SUBJECT: Transmittal of Revised Westinghouse Proprietary and Non-Proprietary Responses to U.S. Nuclear Regulatory Commission Requests for Additional for the AP1000 Application for Design Certification

Westinghouse Revised Non-Proprietary Responses
to US Nuclear Regulatory Commission
Requests for Additional Information
dated March 17, 2003

AP1000 DESIGN CERTIFICATION REVIEW

Figure 440.091-6 Vapor Rate out of the Core

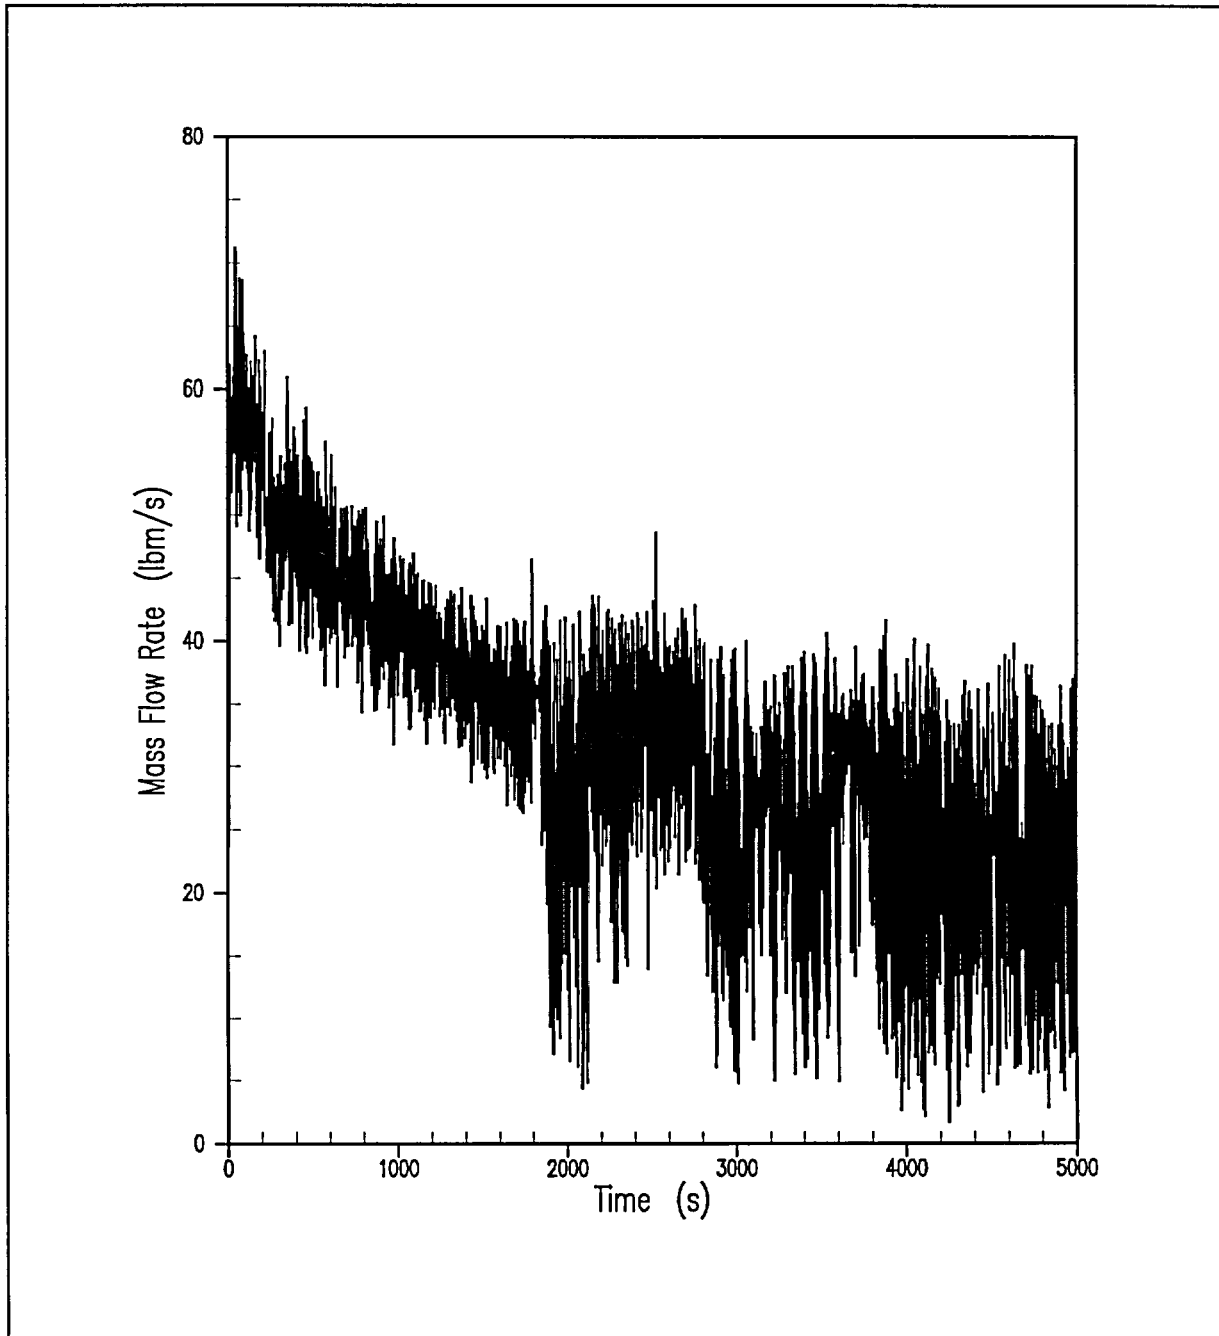
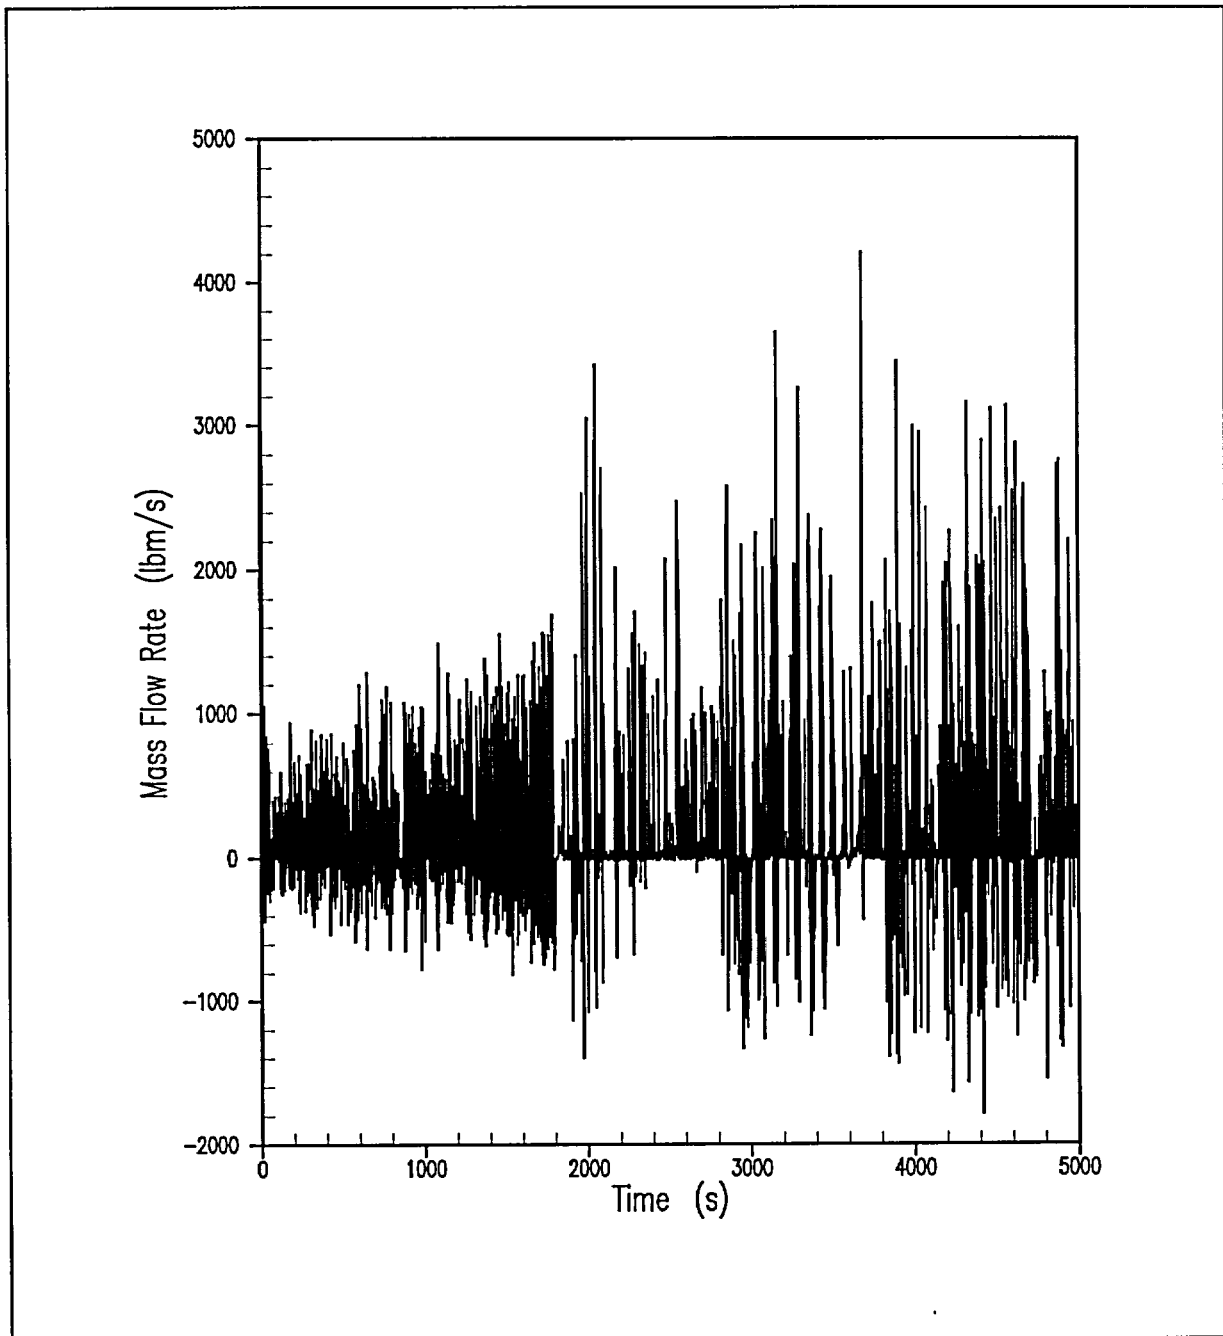
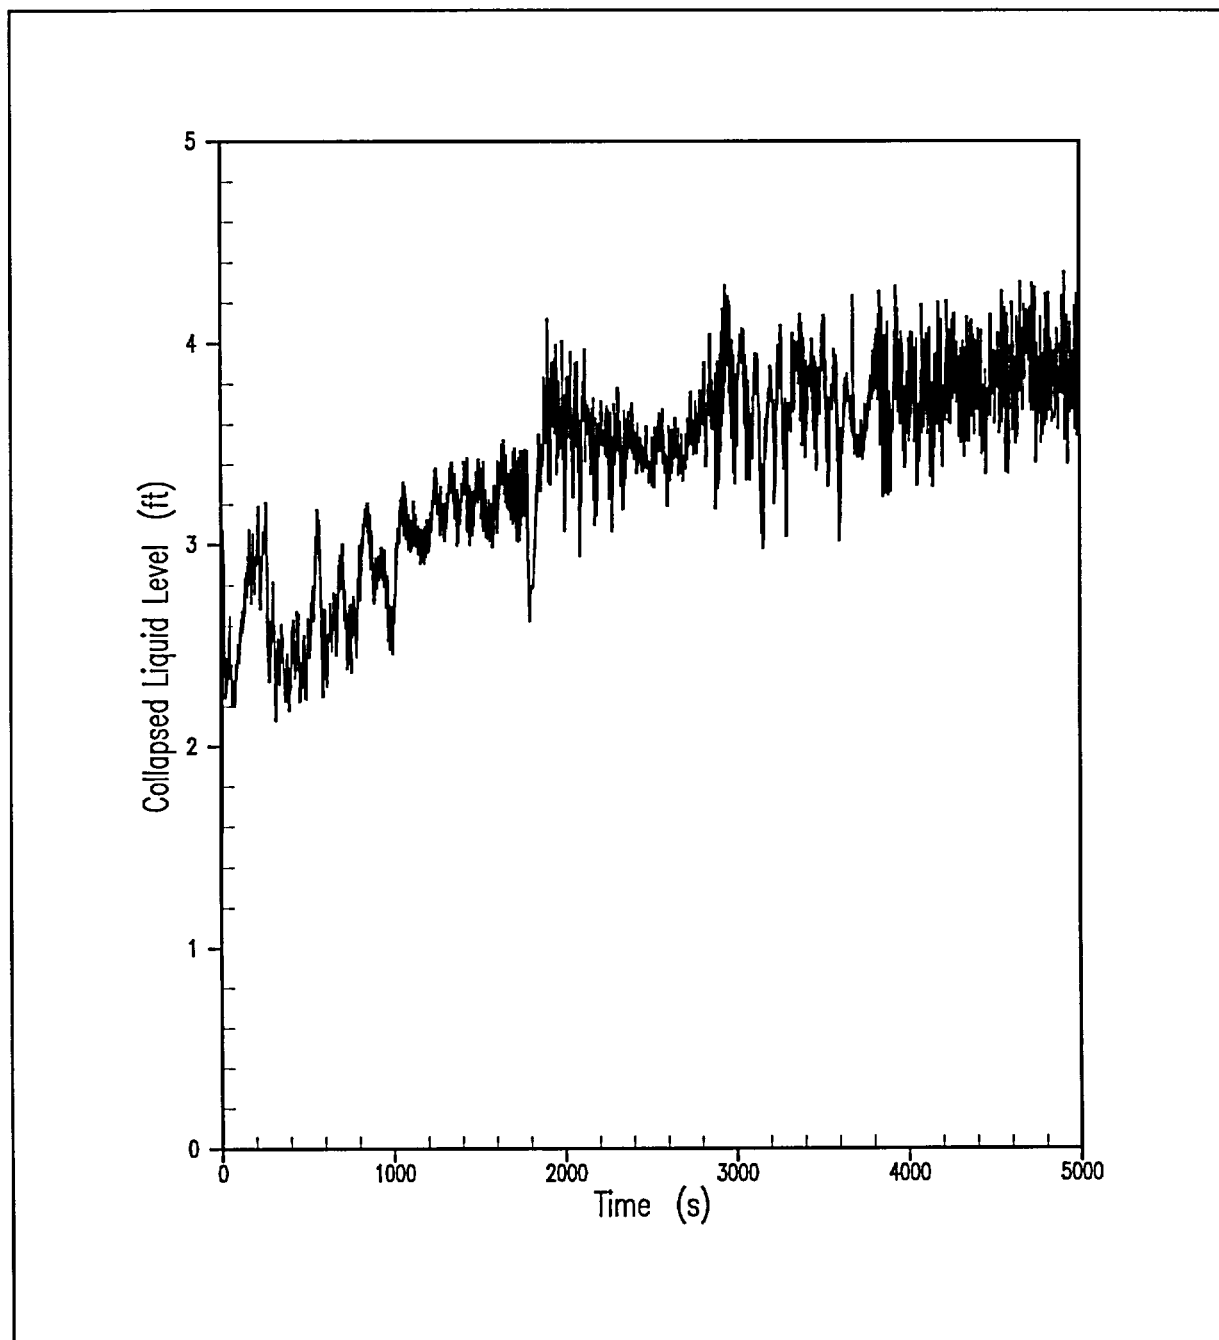
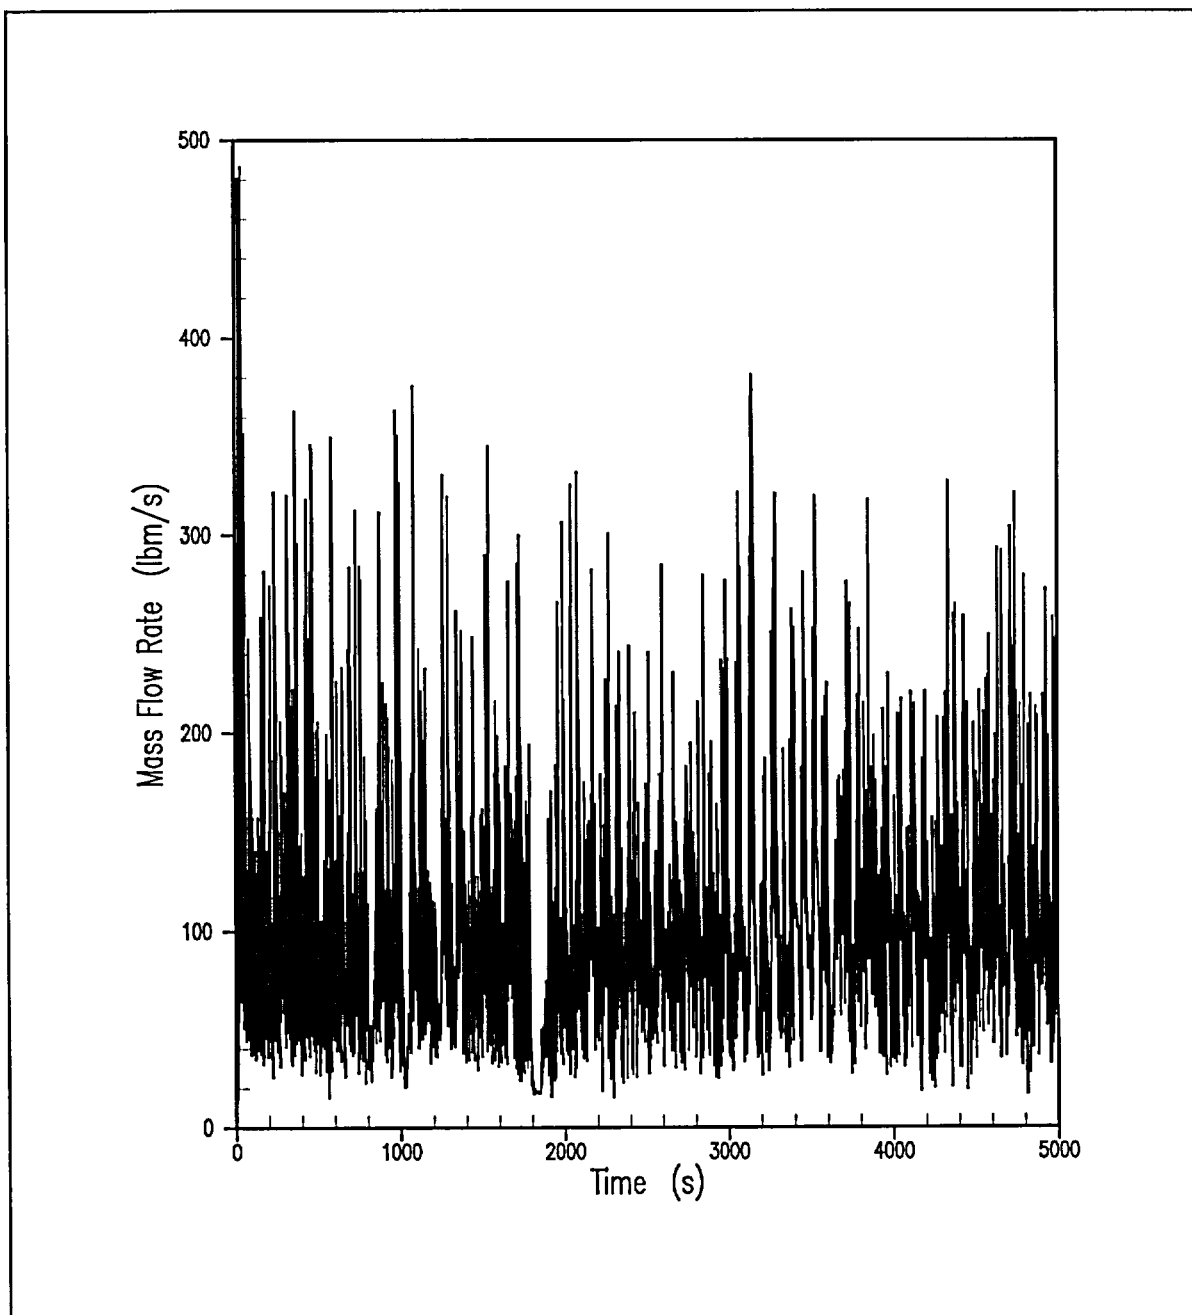
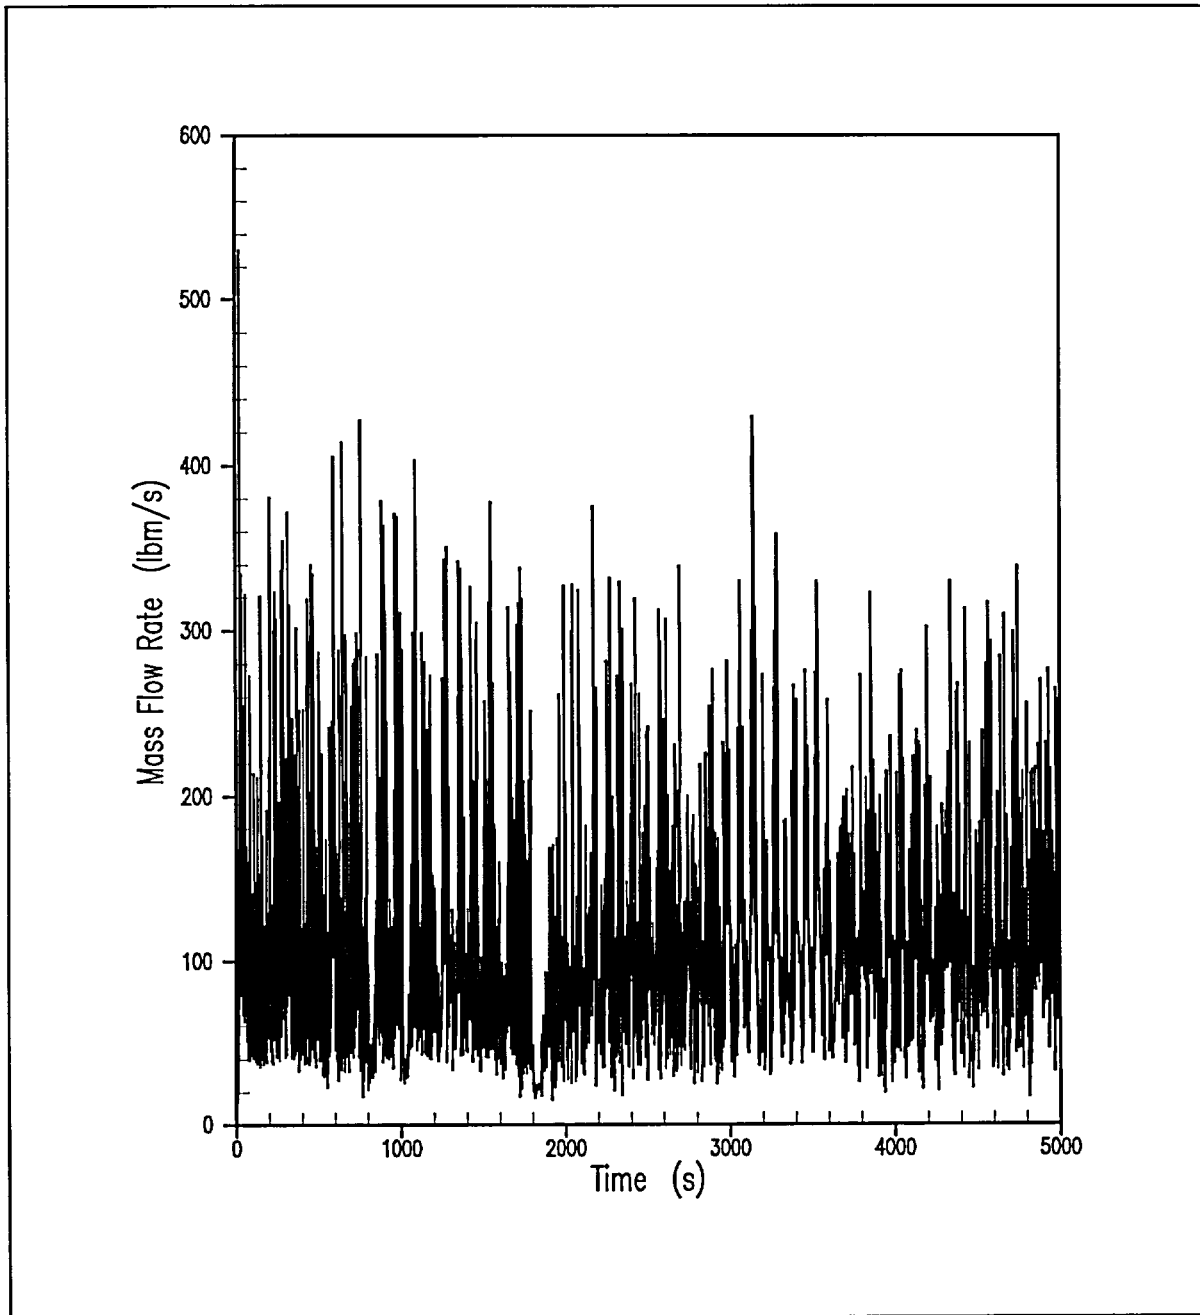
Will that steam velocity be able to entrain and remove liquid from the core? (Note, it is not feasible to draw this conclusion from the information in the code applicability report without extensive calculations.)

The question is concerned with the removal of liquid from the AP1000 core / upper plenum at a minimum steam velocity condition. The concern is whether there exists sufficient liquid carryover out the ADS-4 valves post-LOCA to prevent the potential for boron precipitation in the reactor vessel. As was demonstrated for the AP600, liquid carryover from the ADS-4 valves prevents the reactor vessel boron concentration from approaching the concentration where boron would precipitate. A boron concentration of approximately 35,000 ppm at 240F is necessary to cause boron to precipitate out of solution. Bounding calculations performed for the AP1000 have determined that the maximum post-LOCA boron concentration calculated for the limiting long-term cooling analysis cases presented in the DCD is 5500 ppm. This represents a large margin to the value where boron precipitation could be a concern.

A set of figures is provided presenting the results obtained from the WCOBRA/TRAC run for this scenario. Liquid flow through the ADS-4 flow paths is adequate to ensure that boron will not concentrate in the core. As seen on Figure 440.091-15, the average steam velocity through the ADS-4 Stage 4A flow path in the offtake pipe from the hot legs is 95 ft/sec, while in the DCD case the average steam velocity at the same location is almost 300 ft/sec (Figure 440.091-16). Overall, the figures show that amount of liquid carryover is increased for this scenario. As seen in comparison to the DEDVI long-term cooling analysis results presented in the DCD, the vessel injection is greater, and reactor vessel level is higher throughout the transient. This is primarily due to the faster RCS depressurization resulting from all four ADS-4 valves opening. Even though the vapor velocity in the ADS-4 flow paths is reduced, the core remains covered and cooled, and the liquid carry-over out the ADS-4 is increased (when compared to the cases presented in the DCD). Thus boron precipitation in the reactor vessel will not be a concern for the postulated scenario raised in this RAI.
